GTC Member Proposed Amendments to the Girdwood Trails Master Plan Jan 18 2022.  
Proposed changes may not be addressed in the order shown.

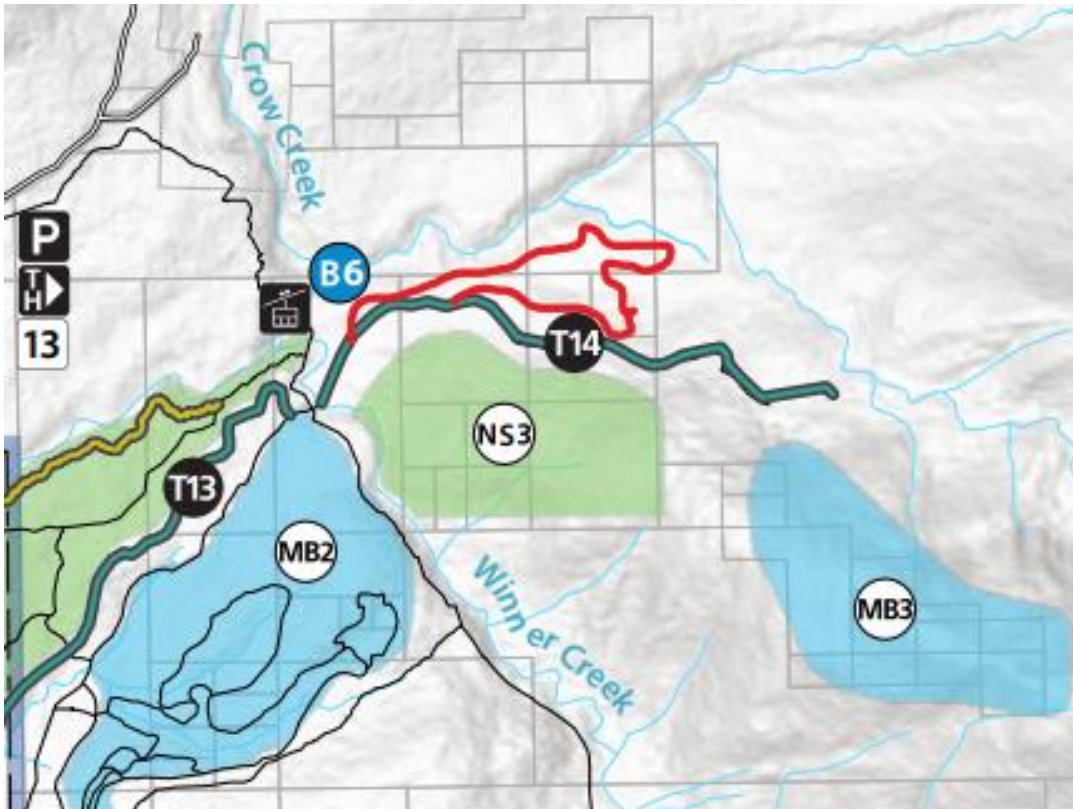
Amendment #2 (Tenny)  
Proposed change: Title - Virgin Creek Falls Trailhead. Keep bullet points 1,2,3  
Add bullet point 4: Upon completion of the study and review of the suggested alternatives by GTC there will be implementation of the preferred option.

Motion: GTC moves to approve Amendment #2 to Virgin Creek Falls Trailhead. Add bullet point 4: Upon completion of the study and review of the suggested alternatives by GTC there will be implementation of the preferred option.

Motion passes 3/1/22

Amendment 13:

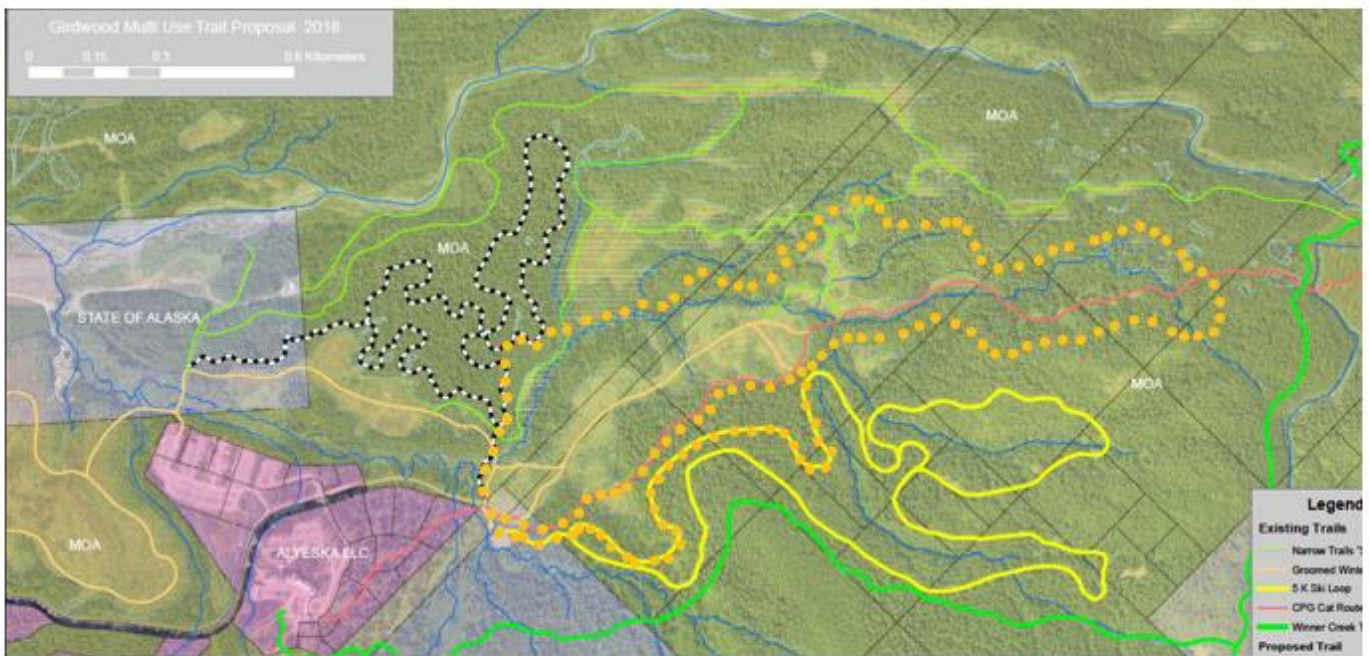
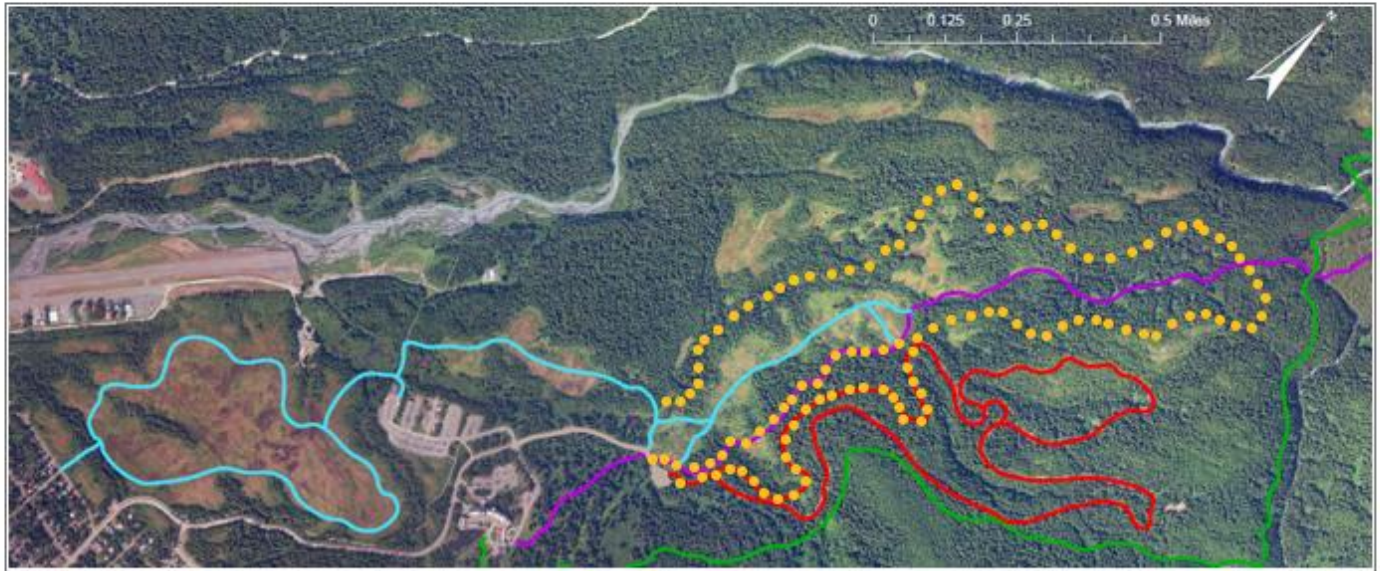
Proposed Motion: add back an Upper Valley Connector from the Forest Loop to the CPG CAT Track near the CAT Track Bridge. (see maps below)

While the exact area of the connector trail can be discussed in the future, showing a Class 4 year-round looped trail system is congruent with the community survey results and Girdwood Master Plan comments. The trail originally included in the plan was removed because people commented the space was crowded. Yet, if you look at the summer map the GTC created (shown below), no summer trails exist in this area. This area has been repeatedly zoned and defined as Open Space and Recreation Zone. In 2006, HLB commissioned a trail feasibility study to determine where to add 20 Kilometers of multi-use trails to this area. I agree that the primitive trails should remain primitive, but I disagree with this proposed primitive area covering all of the uplands of the Girdwood valley west of the CAT track, thus prohibiting a future multi-use trail system development that includes summer or winter bike travel.

Motion to add back an Upper Valley Connector from the Forest loop to the CPG Cat Track near the Cat Track Bridge.

Motion carries.
